8608 Service Bulletin.

Steel hydraulic lines for cut off cylinders.

8/8/2024

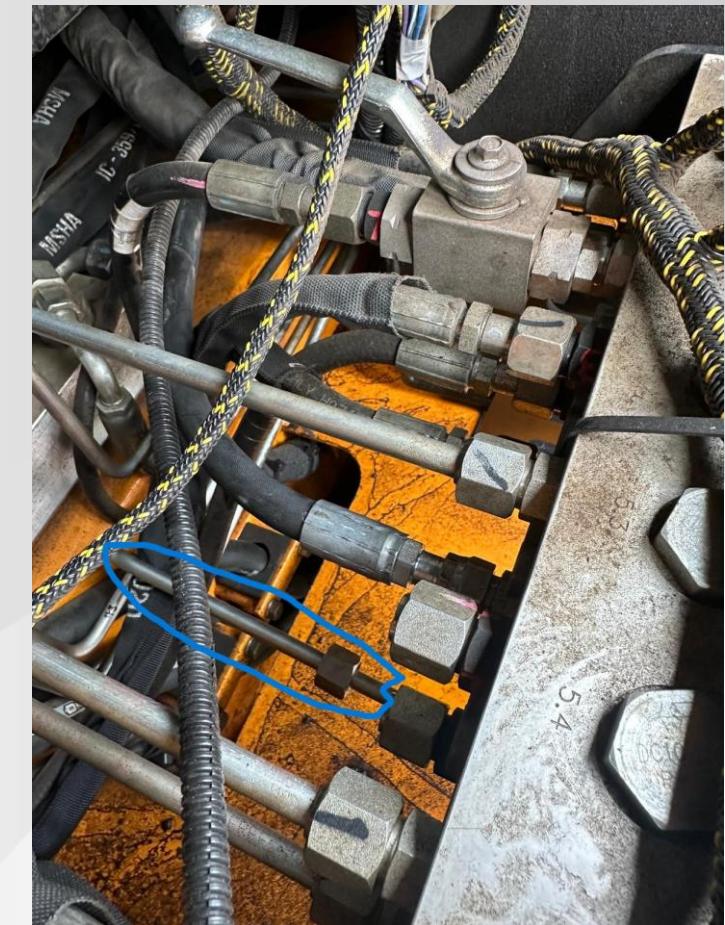
Located inside the left side engine access door.

Steel lines behind the left and right cutoff cylinder valves.

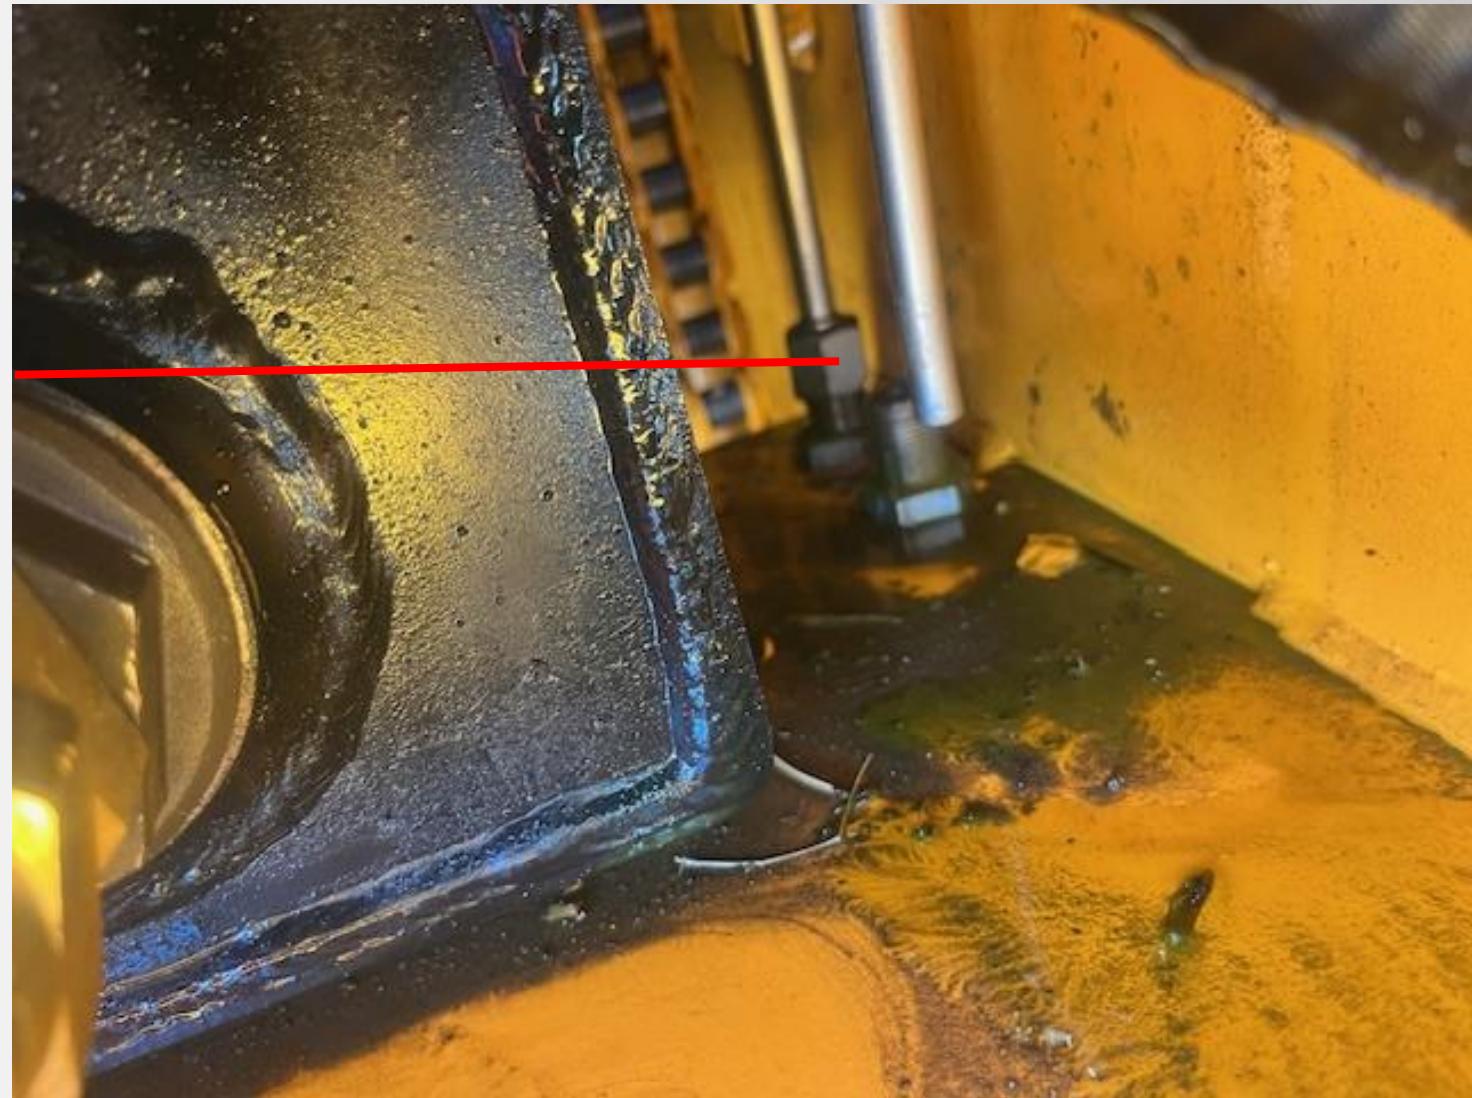
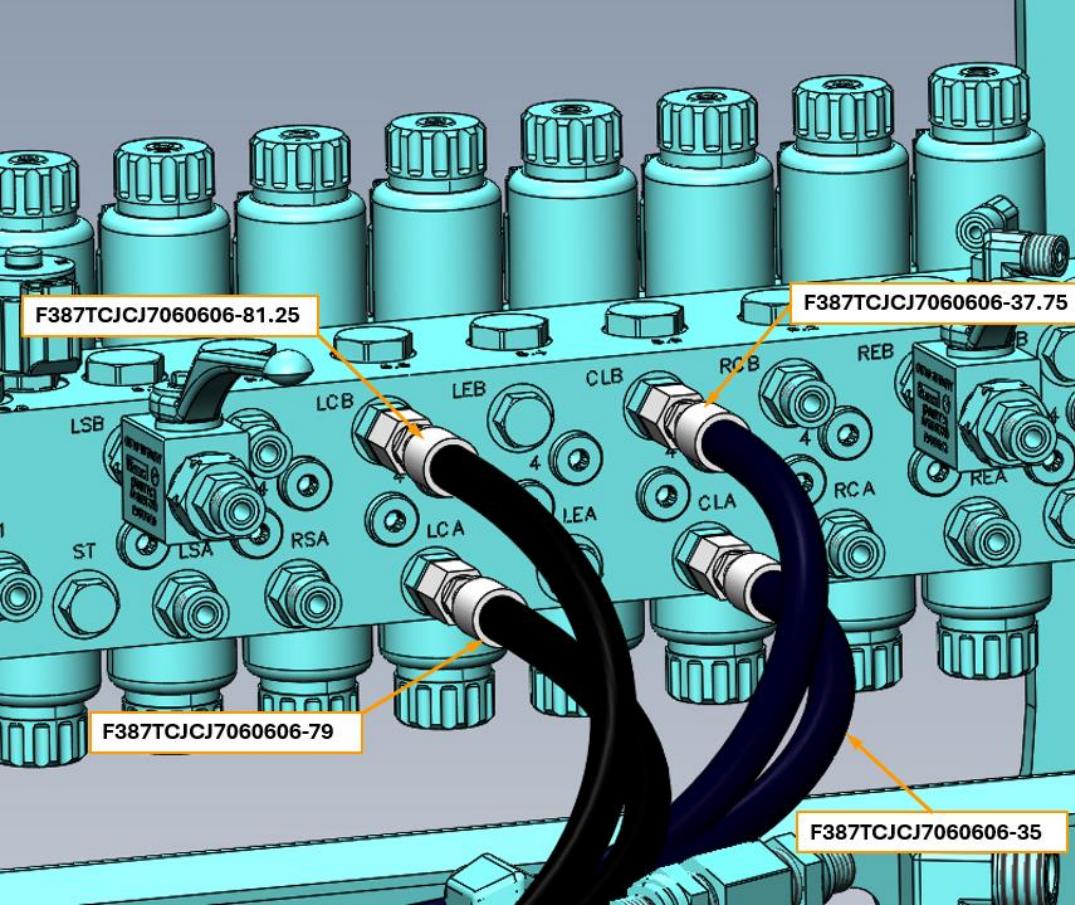
Inside the right and left engine access doors, Cutoff cylinder line bulkheads are located between tank and frame.

Use ratchet and a couple of extensions with a 21mm crow foot to remove the lines.

This will take 2 people to line the crow foot and Turn the nut to remove it.

Cut them, pull them out to discard.

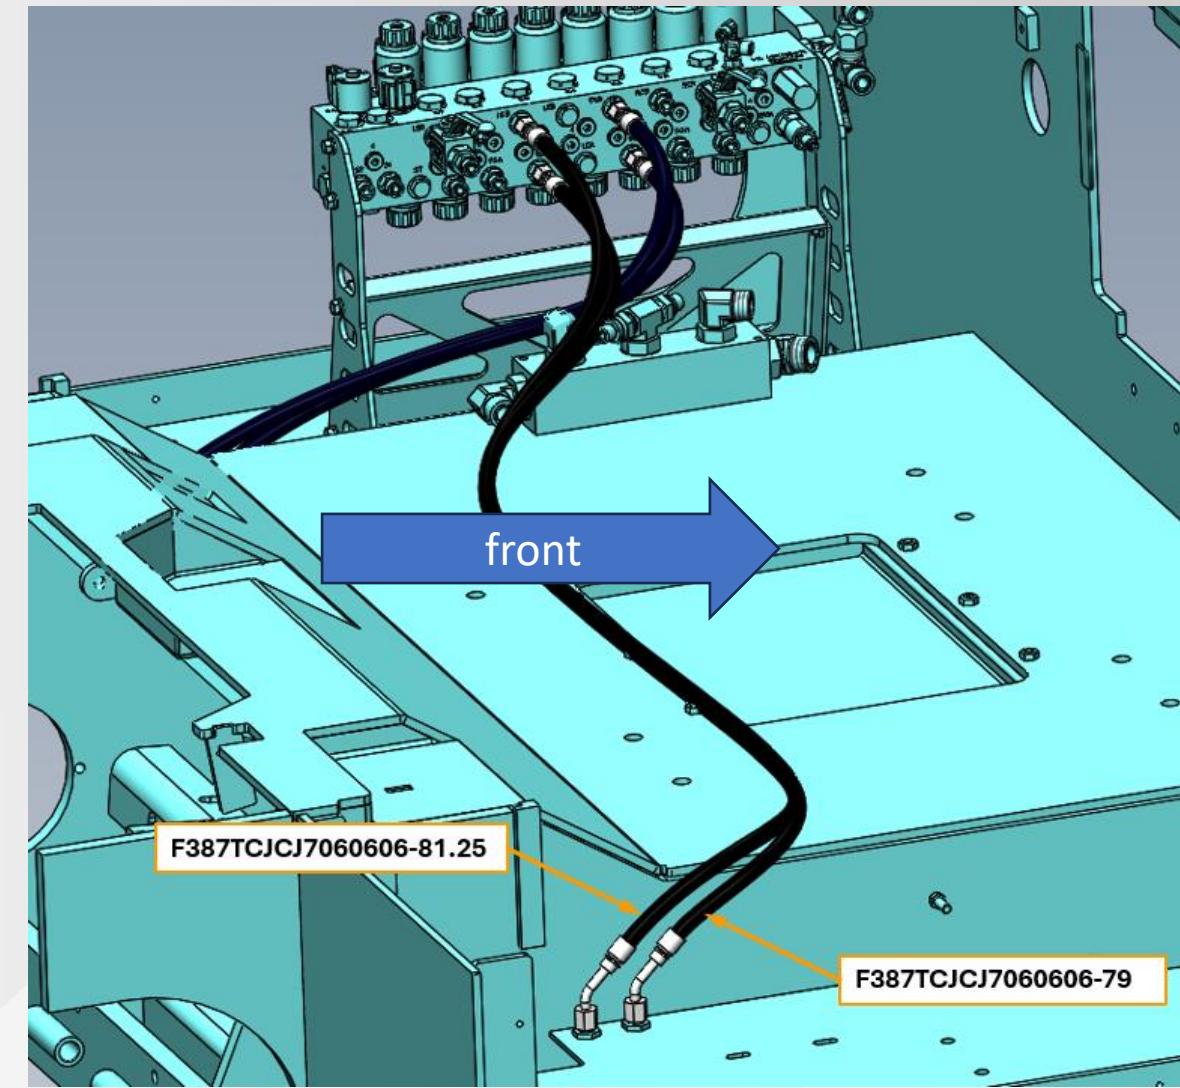
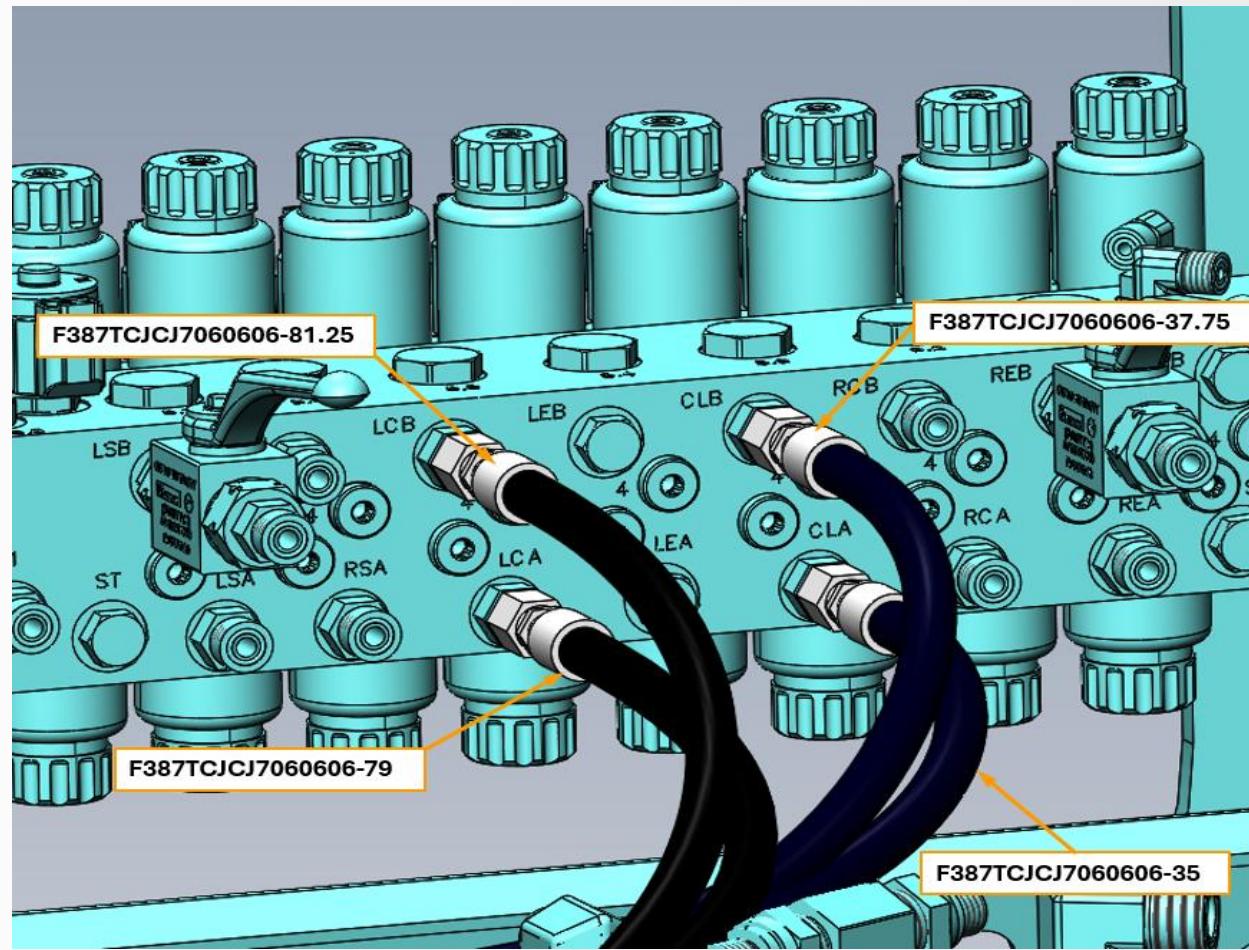
Hoses are identified with part number and length.
The number after the dash is the length.

Hoses 85.25 and 79 both rout under the engine.

Hose 81.25 to LCB port

Hose 79 to LCA port

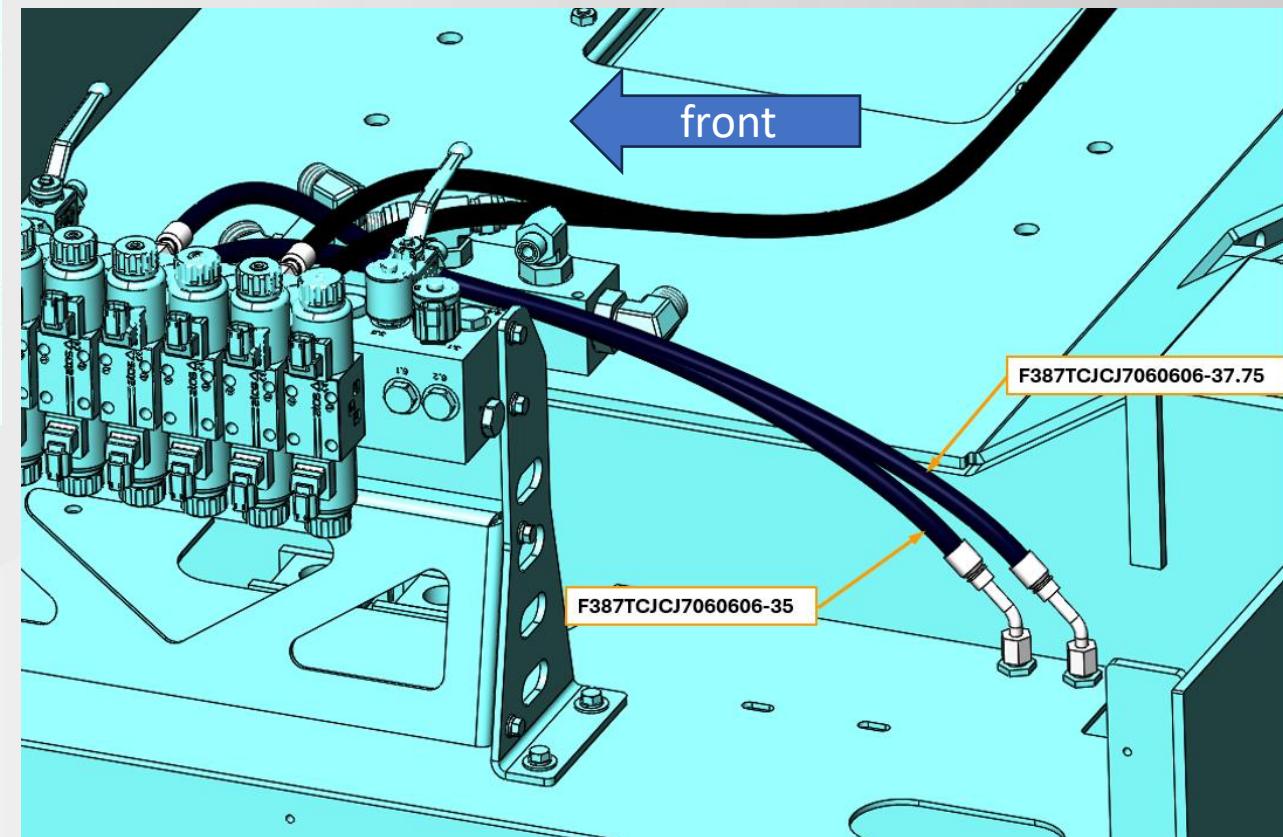
Hose 37.75 goes to port CLB

Hose 35 goes to port CLA
